**KERN DELTA WATER DISTRICT – OLD RIVER BASINS GRADING PROJECT
PRE-BID MEETING SUMMARY AND CLARIFICATIONS
NOVEMBER 3, 2022**

Requests for Information – Through November 1, 2022

C-10 Canal Gate Ordering Information

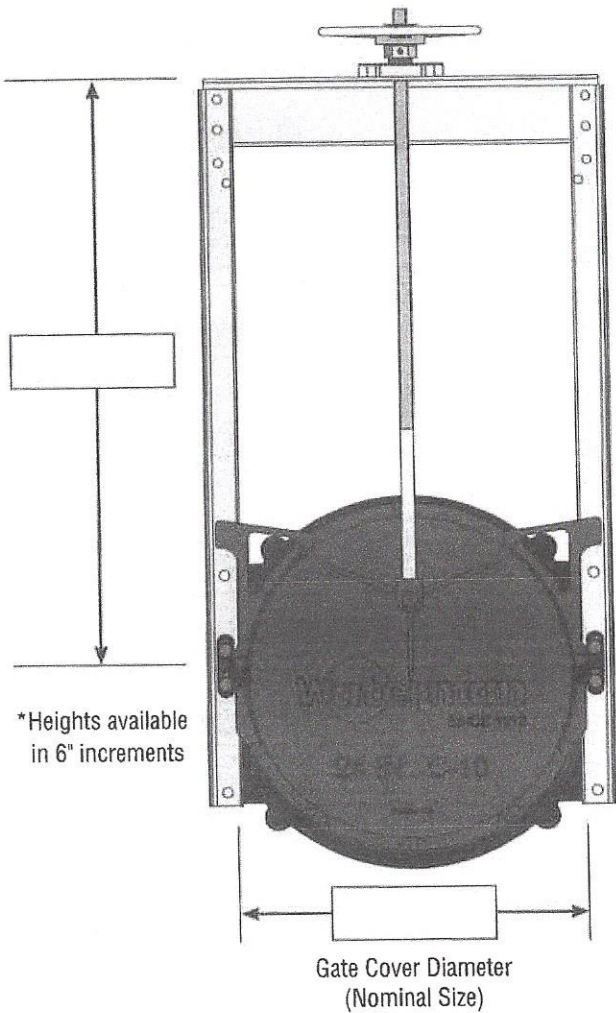
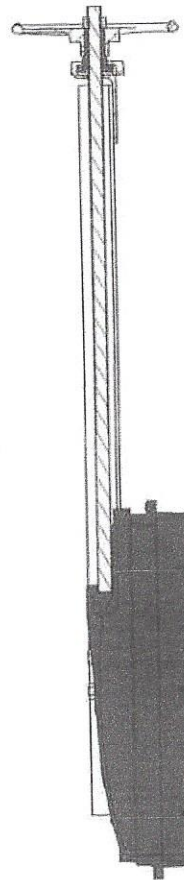
For the Waterman C-10 Canal Gates:

1. Shall the frames be galvanized or type 304 stainless steel?
2. Shall the stems be cold-rolled or type 304 stainless steel?
3. Shall the lifts be standard or type 2 (ball bearing)?
4. What shall the diameter of the handwheel be?

1. The frames shall be galvanized steel.
2. The stems shall be cold rolled steel.
3. The lifts shall be standard, per Waterman.
4. The handwheels shall be standard, per Waterman.

See the attached mark-up of the C-10 Canal Gate Ordering Information Form below:
